**SITE PLAN REVIEW TECHNICAL ADVISORY COMMITTEE  
PORTSMOUTH, NEW HAMPSHIRE**

- A. The request of **Atlas Commons LLC (Owner)**, for property located on **581 Lafayette Road** requesting Site Plan review approval for two 4-story additions to the existing building that will total 72 residential units with associated site improvements including lighting, utilities, landscaping, and stormwater treatment/management. Said property is located on Assessor Map 229 Lot 8B and lies within the Gateway Corridor (G1) District. (LU-23-189)

**SITE PLAN REVIEW TECHNICAL ADVISORY COMMITTEE  
PORTSMOUTH, NEW HAMPSHIRE**

**RE: Submission for Conditional Use Permit and Site Plan Approval at 581 Lafayette Road; Mixed Use Development; Tax Map 229 Lot 8B**

**PUBLIC REALM PLAN**

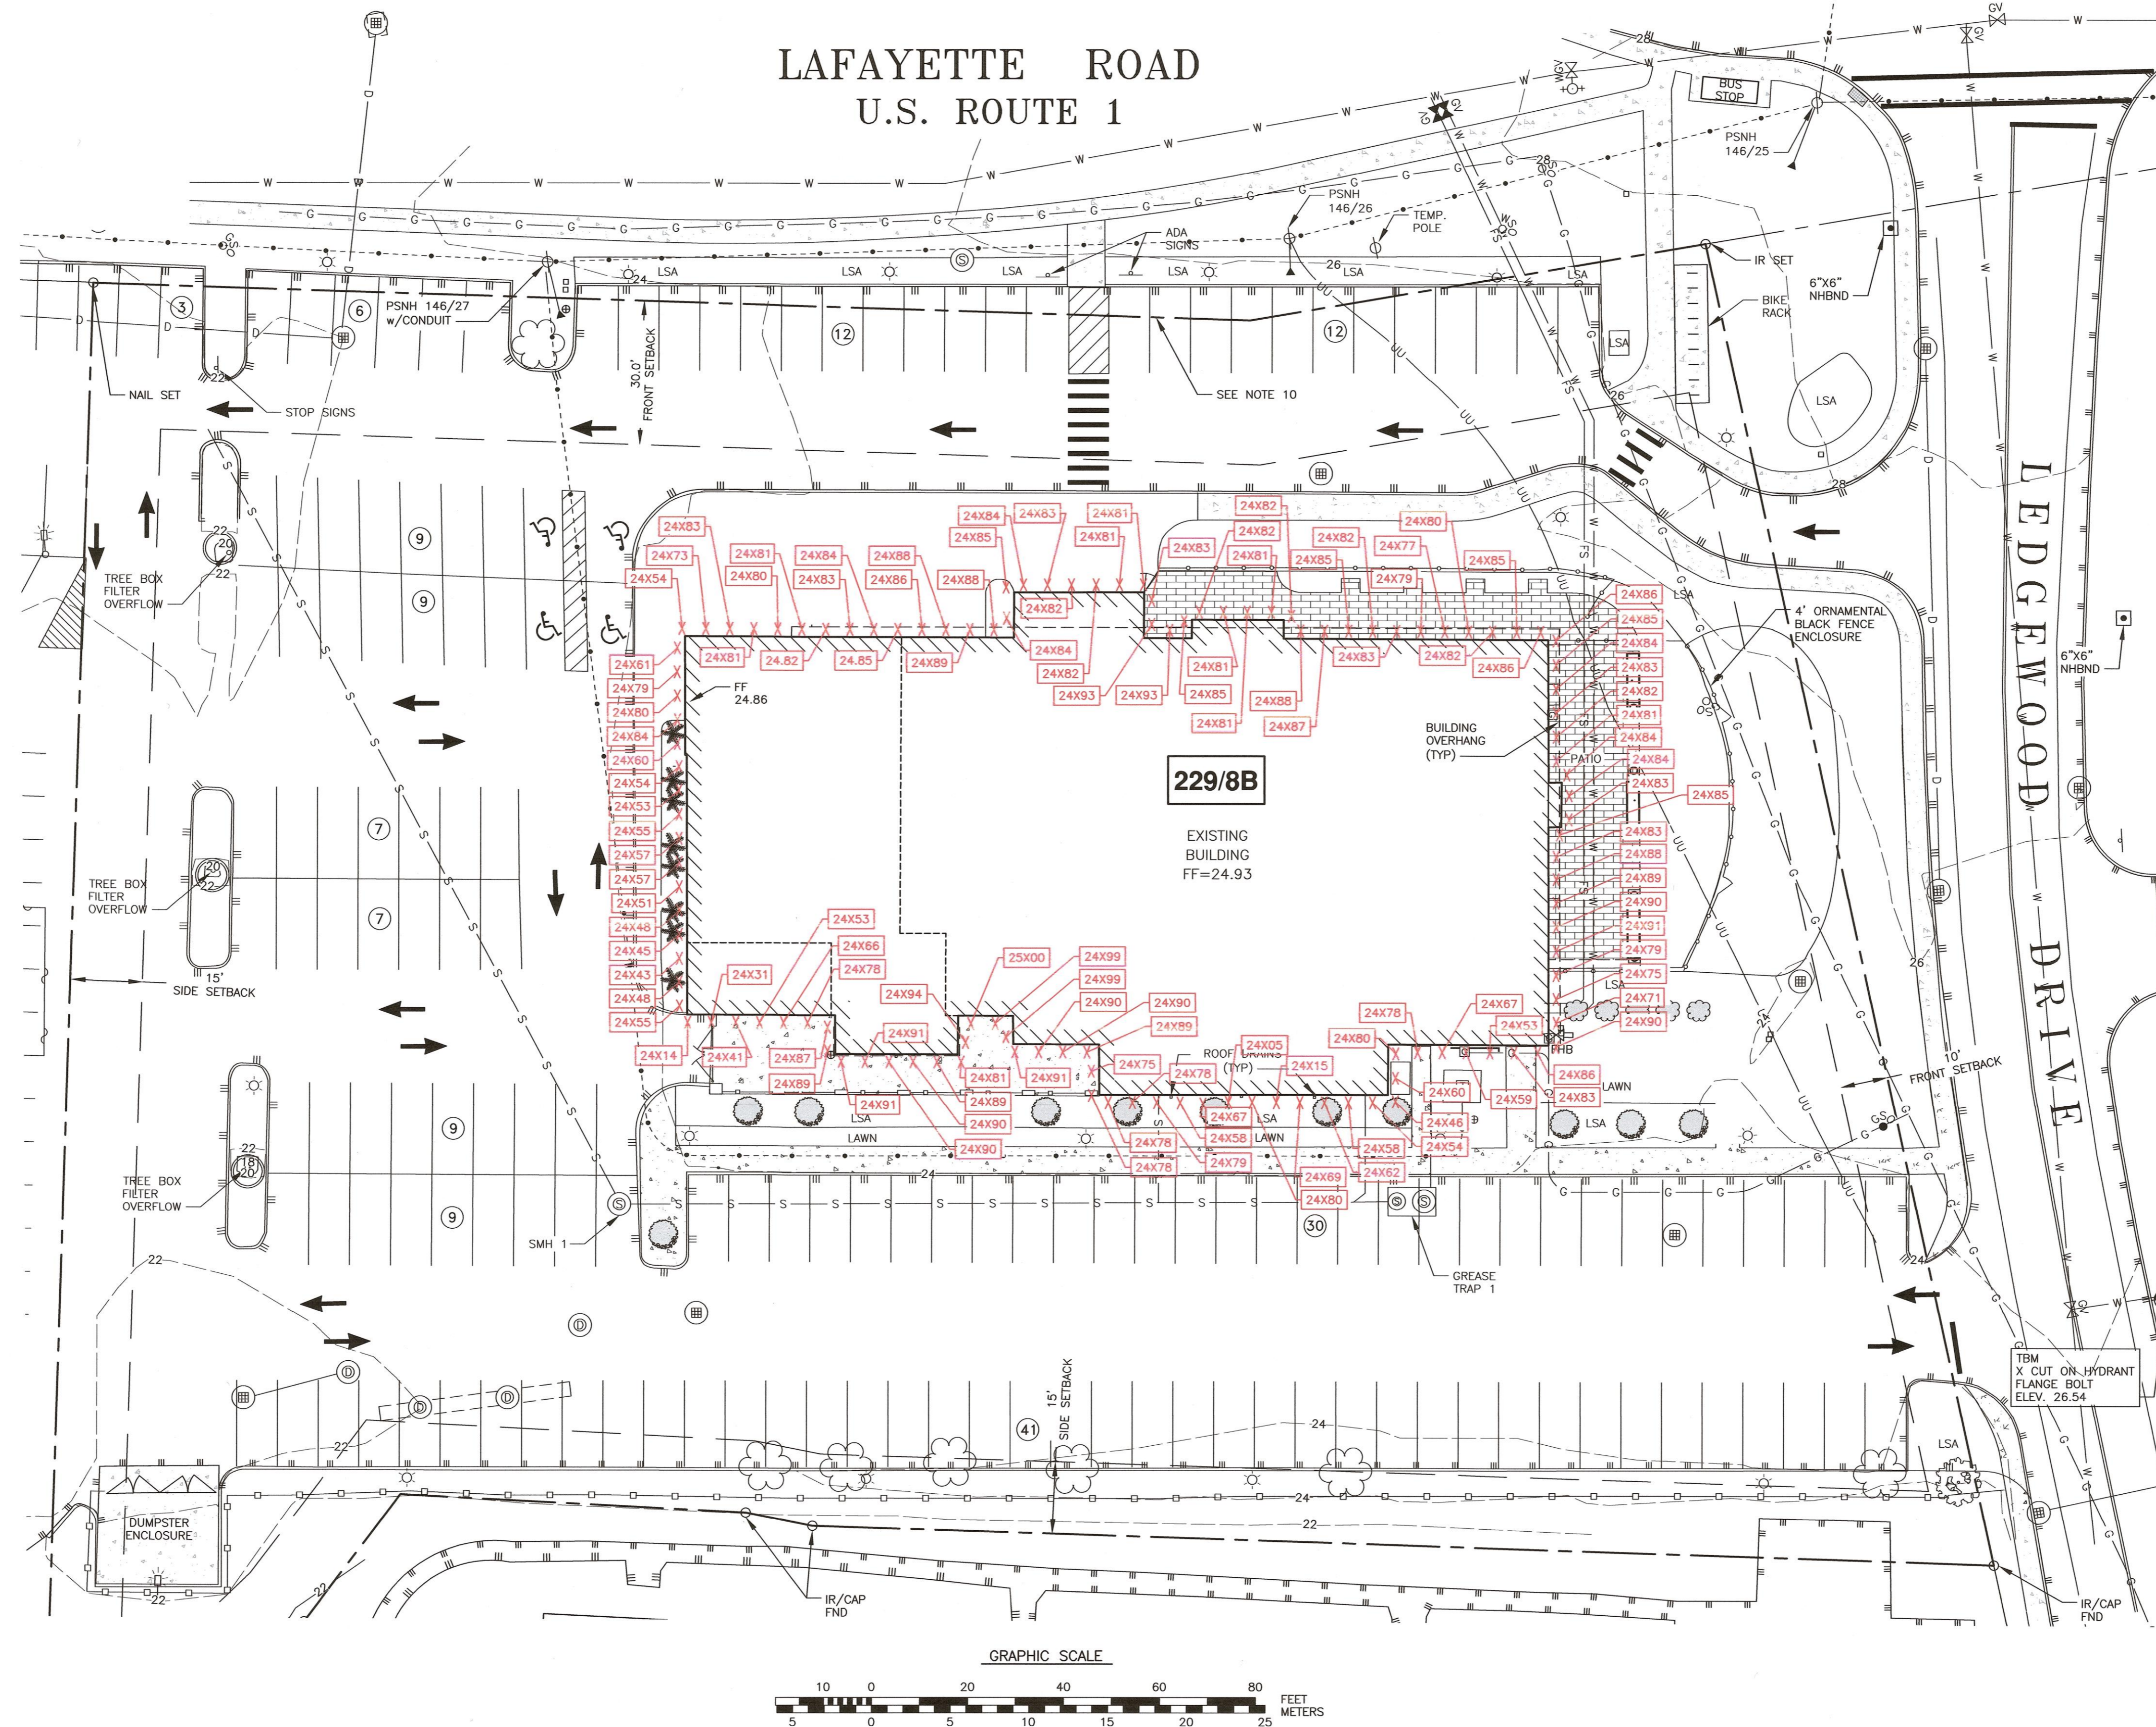
They have revised the trail to now connect to Andrew Jarvis Drive. See Sheets C9 and C10.

**Y** COMMERCIAL EFFLUENT PUMP STATION NTS  
**C5** OR APPROVED EQUAL

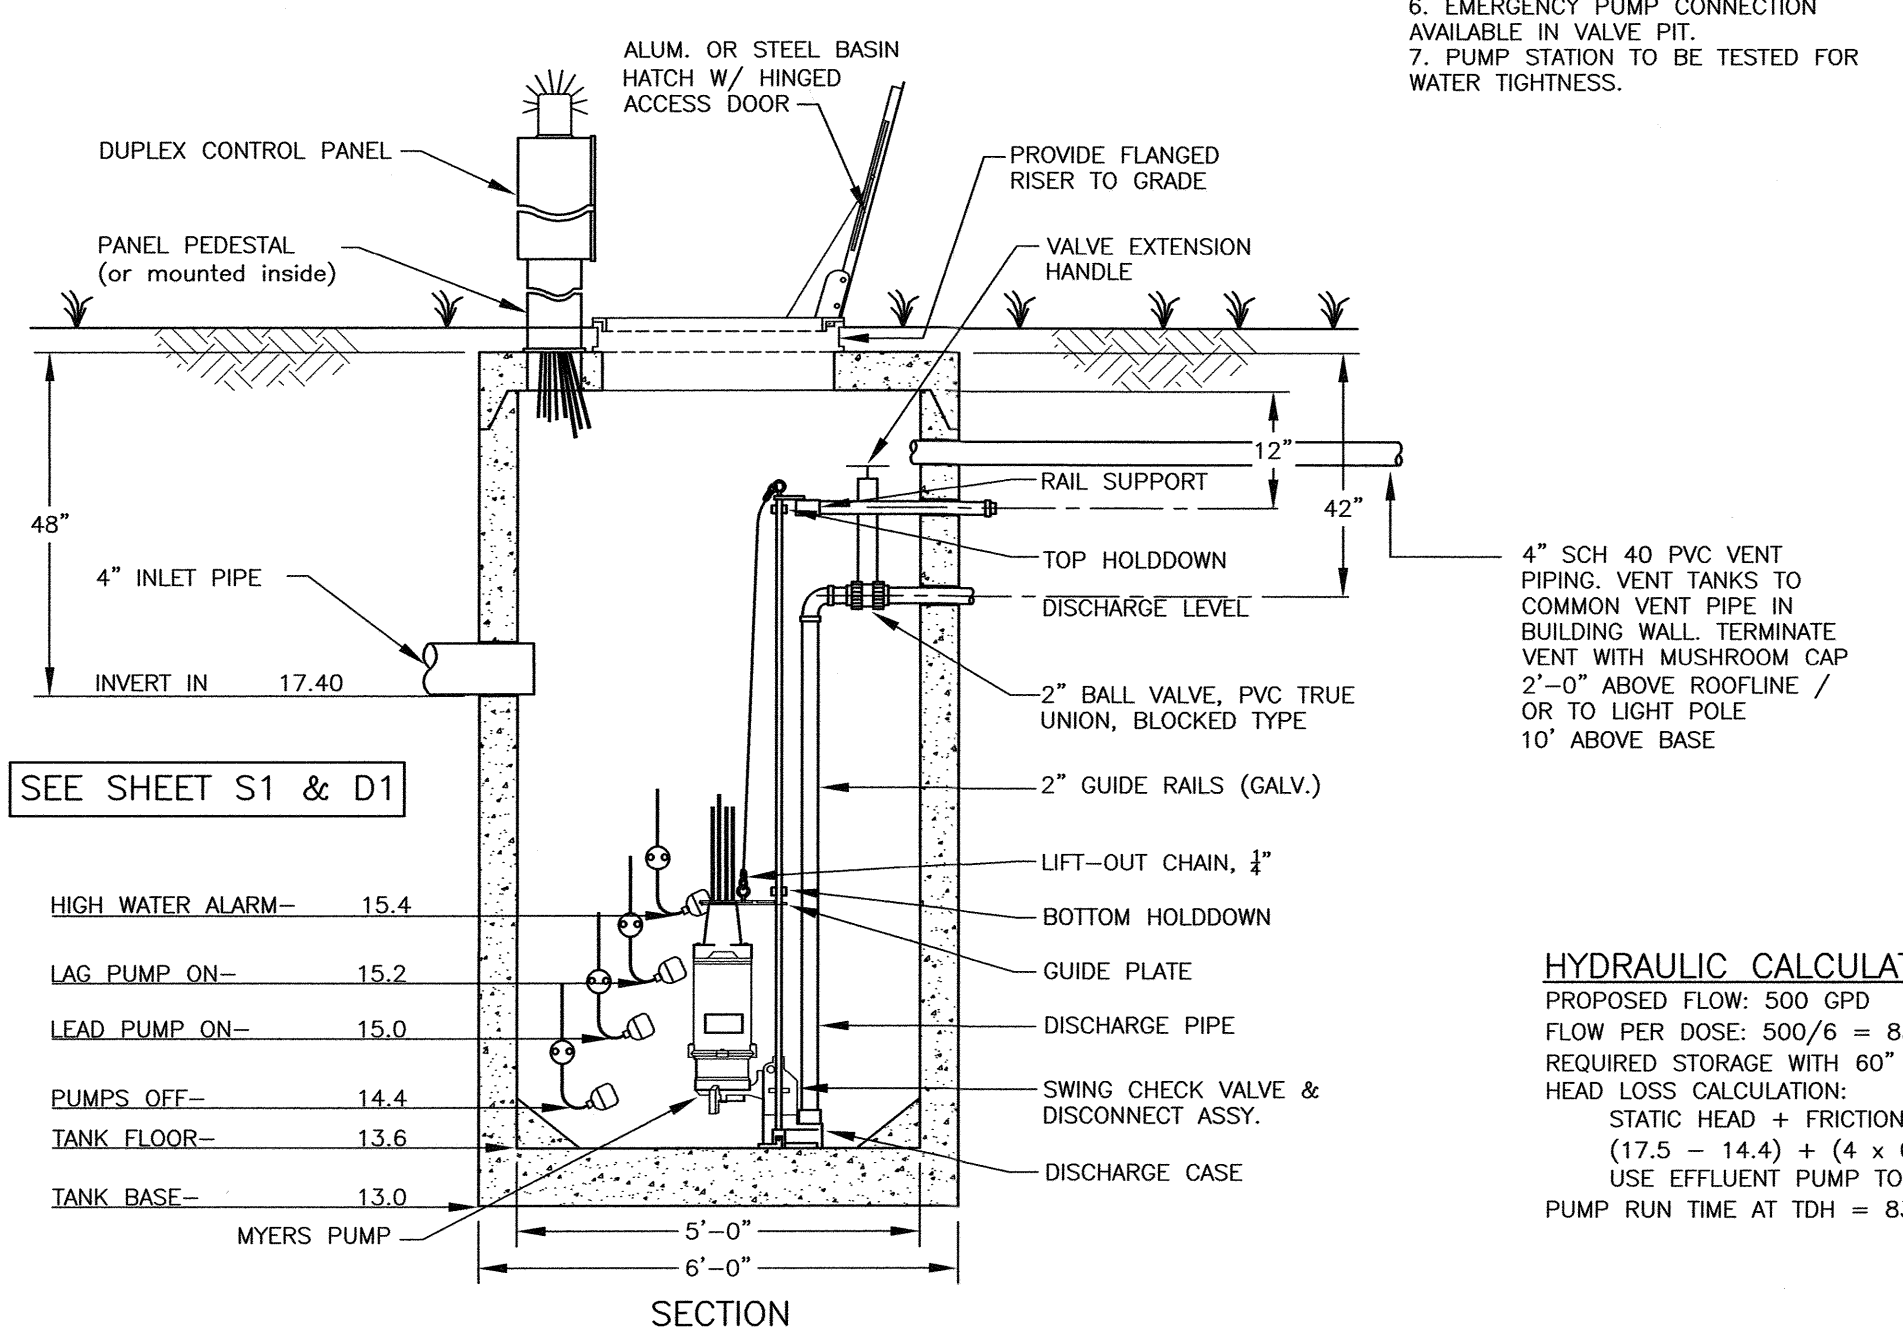
*27. Details on proposed pump station show 1 ½" discharge pipe and utility plan shows 2". Confirm size and pipe materials.*

The detail has been added to Sheet D6, it will be 500 gal/day with the pump running at 20 gal/minute.

The detail has been revised to show 2" pipes only.
